RESOLUTION NO. 2099

**EAST NORRITON TOWNSHIP
MONTGOMERY COUNTY, PENNSYLVANIA**

**A RESOLUTION GRANTING CONDITIONAL, PRELIMINARY/FINAL
APPROVAL OF THE APPLICATION FOR THE LAND DEVELOPMENT OF DUNN-
NOBLE REALTY FOR THE WALGREENS DRUGSTORE LOCATED AT DEKALB
PIKE AND EAST TOWNSHIP LINE ROAD.**

EXHIBIT "B"

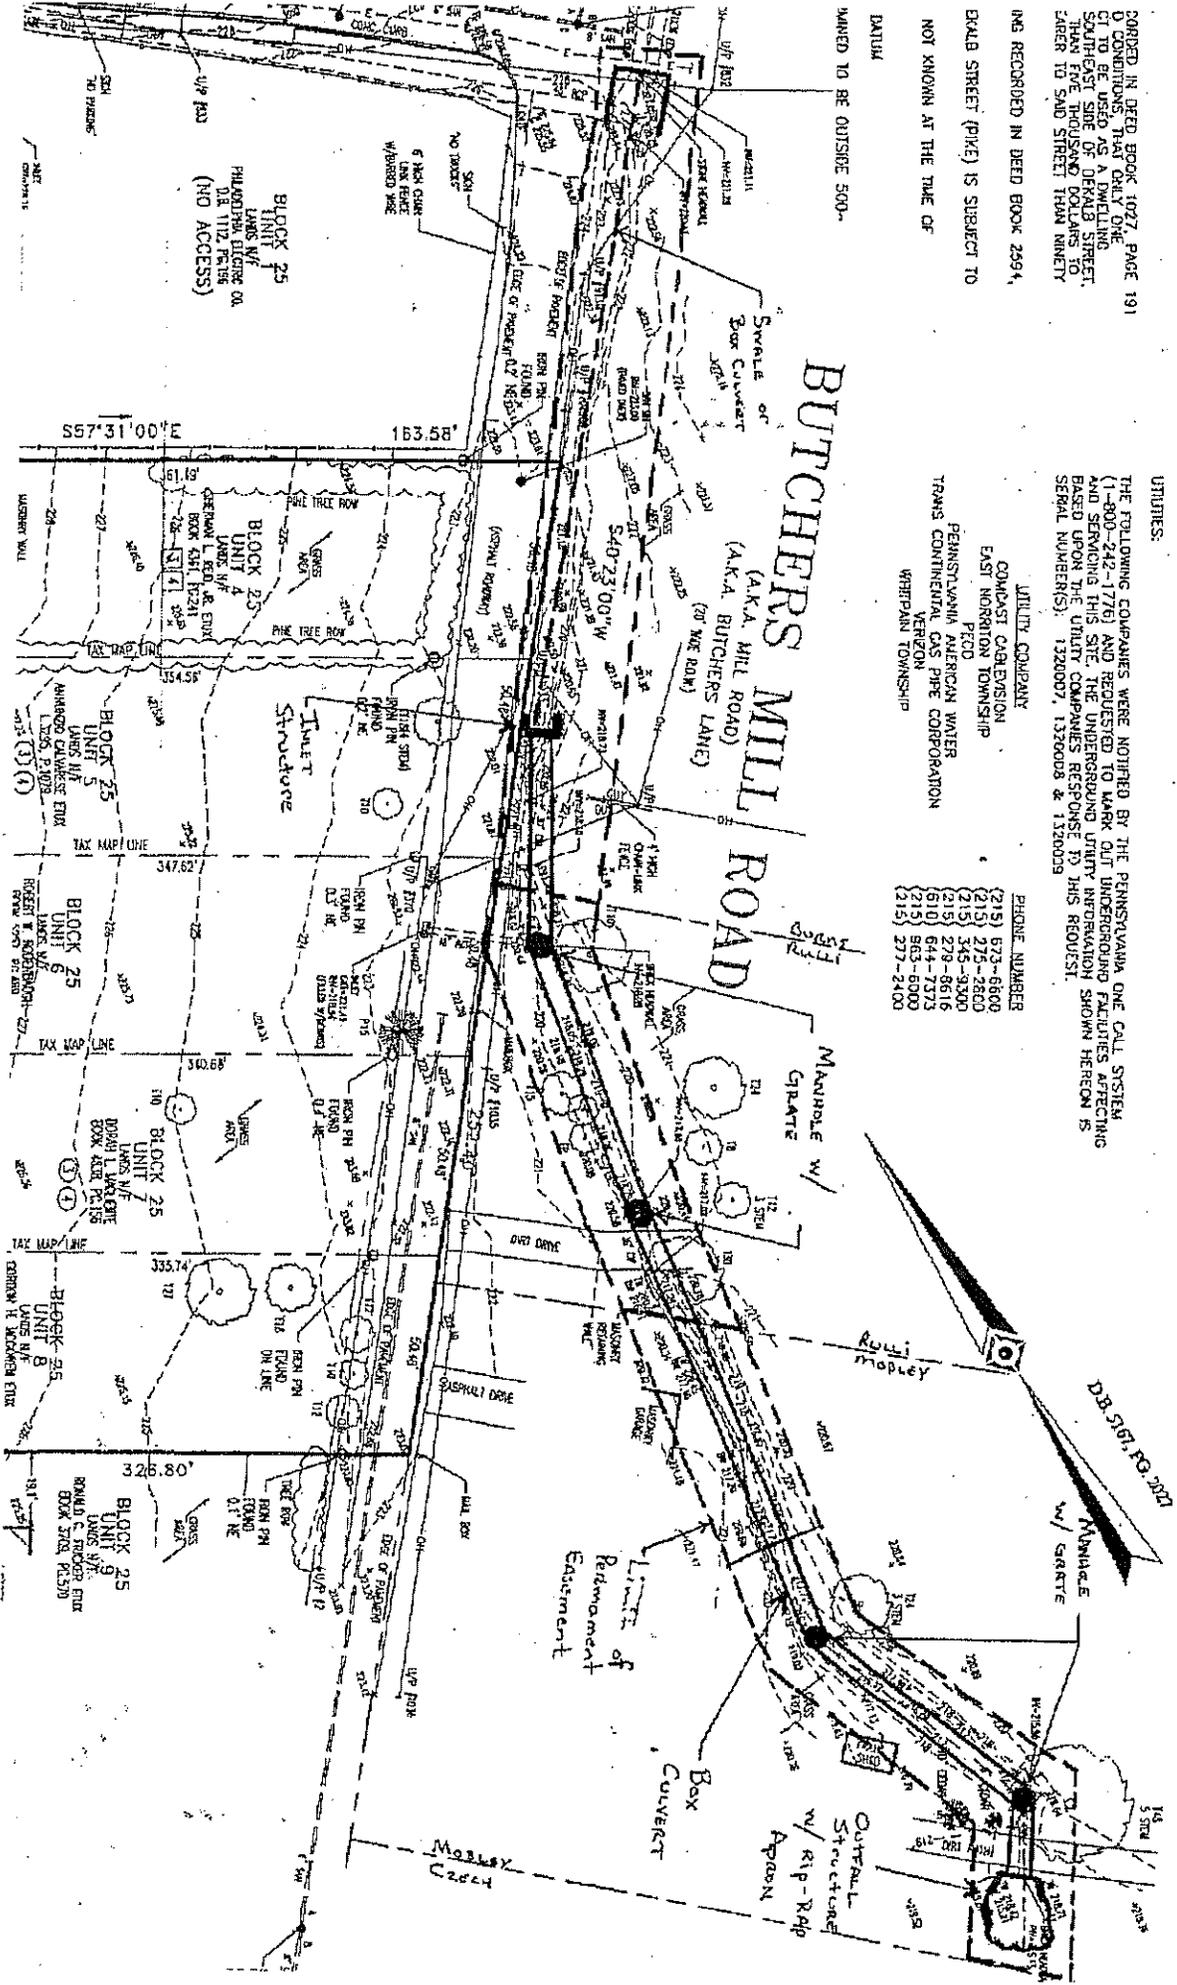
6. The Applicant shall provide engineering designs, legal descriptions, and easements for the SWM system from Township Line Road, along Butchers Mill Road, through the Mobley property, and terminating at the Czech property. The Applicant shall provide a design that is substantially similar to that attached hereto and made a part hereof as Exhibit “B”.
